| Request   | - | Major Site Plan Review for new senior housing facility                       |
| Location  | - | 3837 Secor Road (portion)  |

MAJOR SITE PLAN REVIEW  
TOLEDO CITY PLAN COMMISSION  
REF: SPR-23-20  
DATE: September 10, 2020  
TIME: 2:00 P.M.

C5 / C12

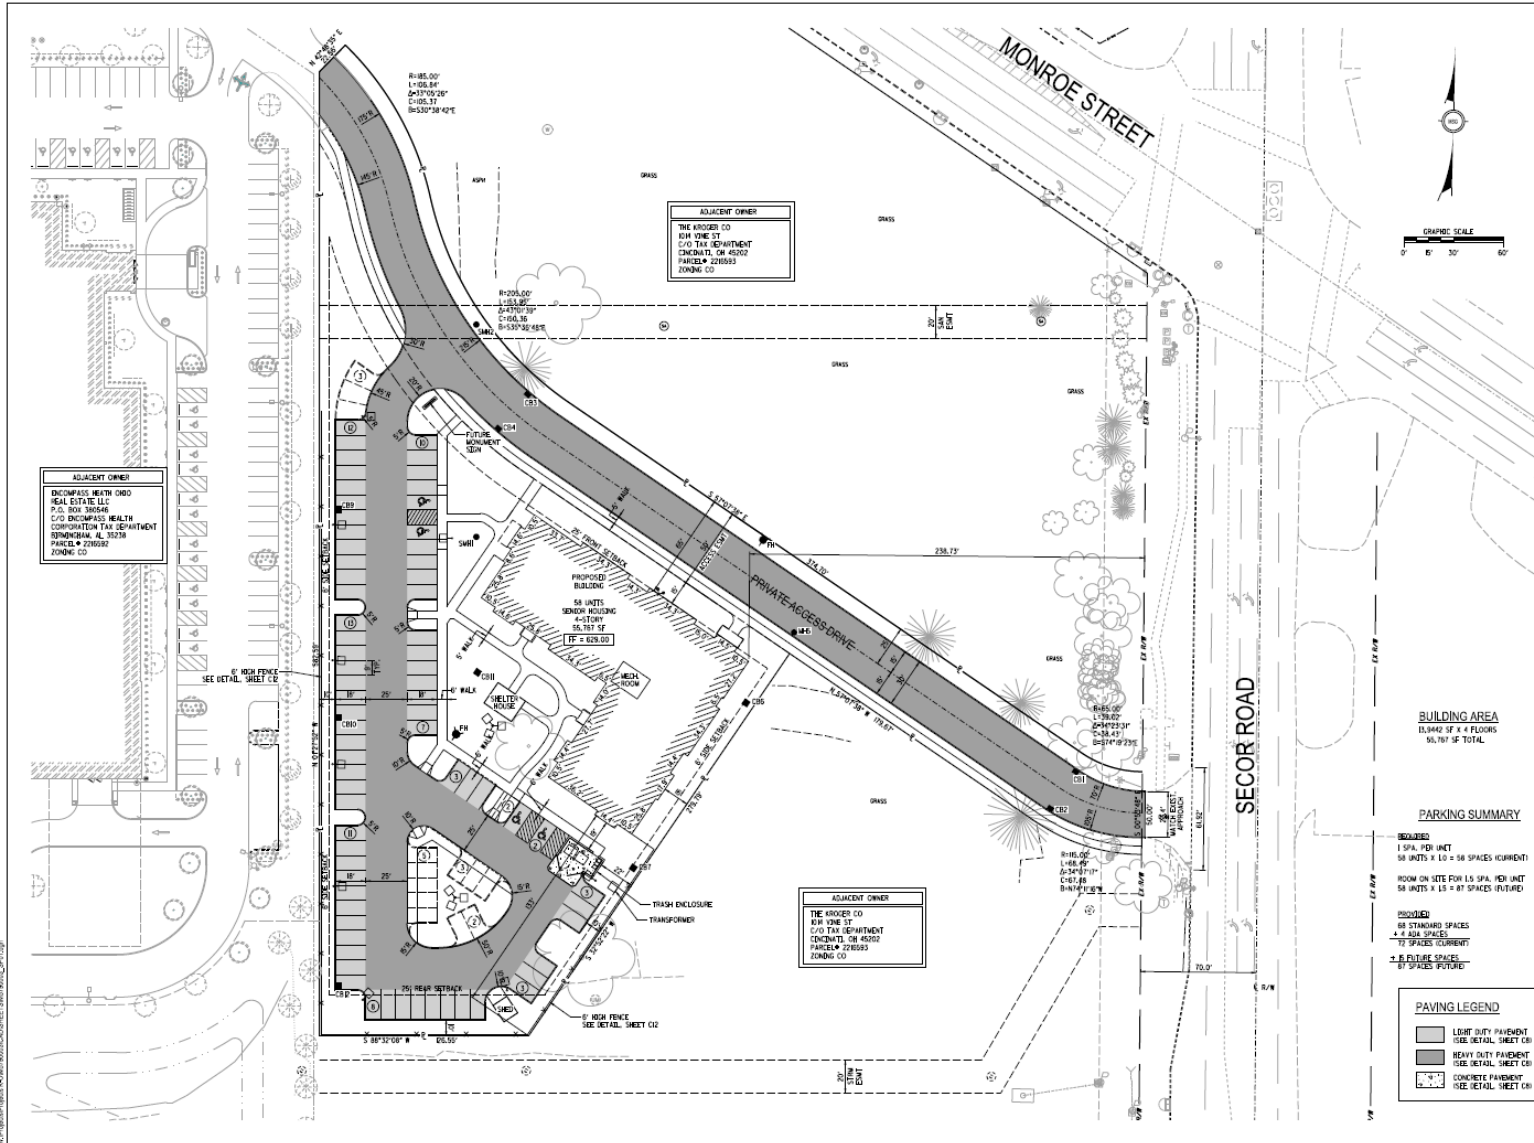
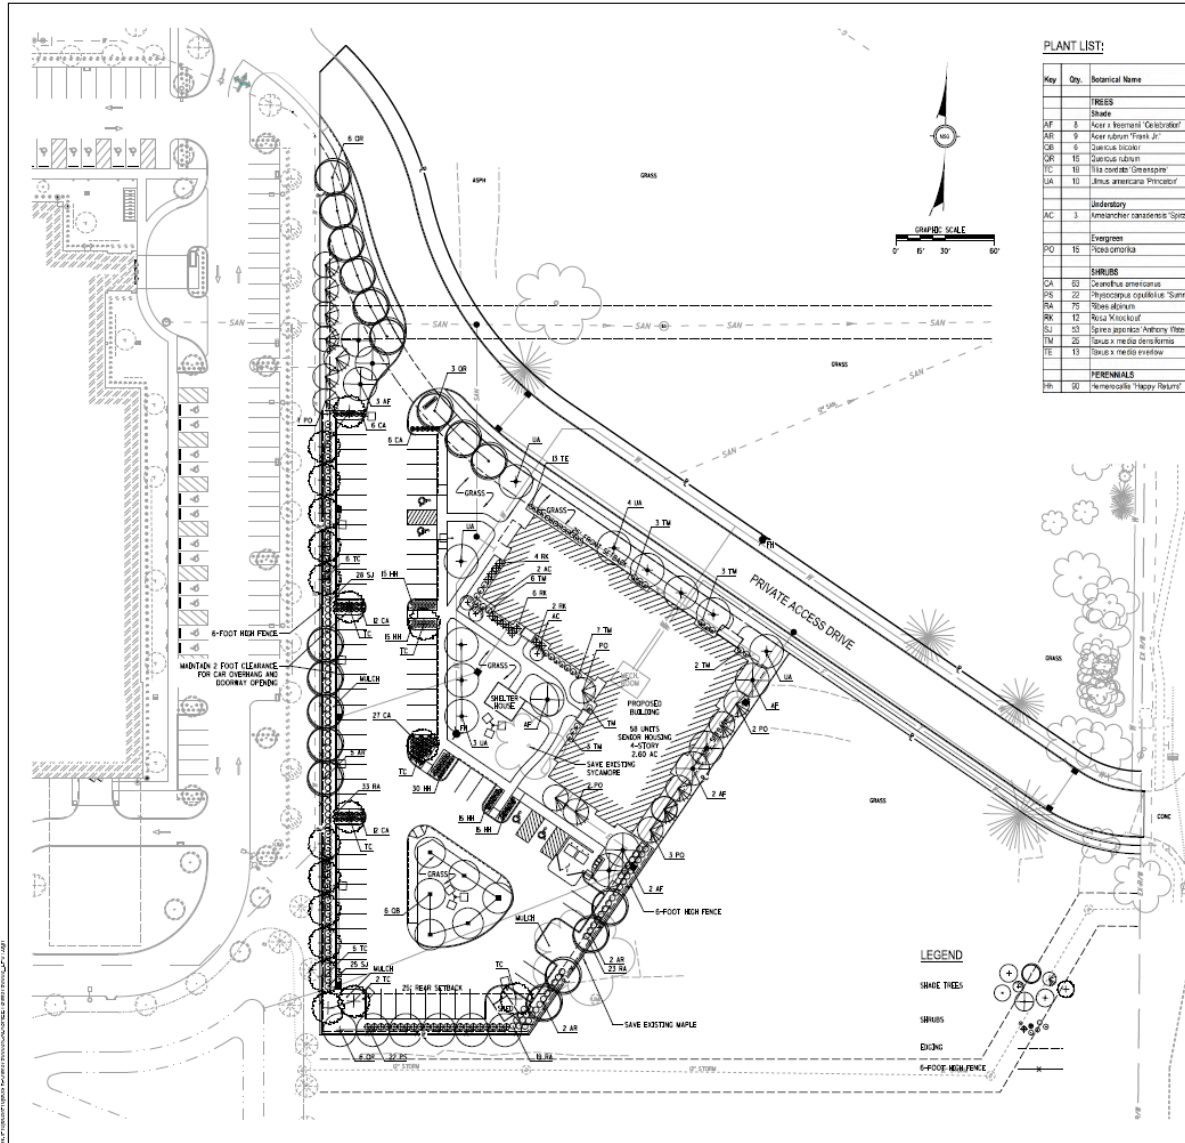
Additionally, bicycle parking slots shall be provided pursuant to Off-Street Parking Schedule "A" (TMC§1107.0900), which requires one (1) bicycle parking slot per ten (10) parking spaces. Calculations conclude that a total of eight (8) bicycle parking slots are required for all seventy-two (72) parking spaces. A bicycle rack with a minimum of eight (8) spaces is required to be shown on a revised site plan.

38. Per TMC§1107.0900, eight (8) bicycle parking spaces are required. **Not acceptable as depicted on site plan. A revised site plan with bicycle parking shall be submitted.**
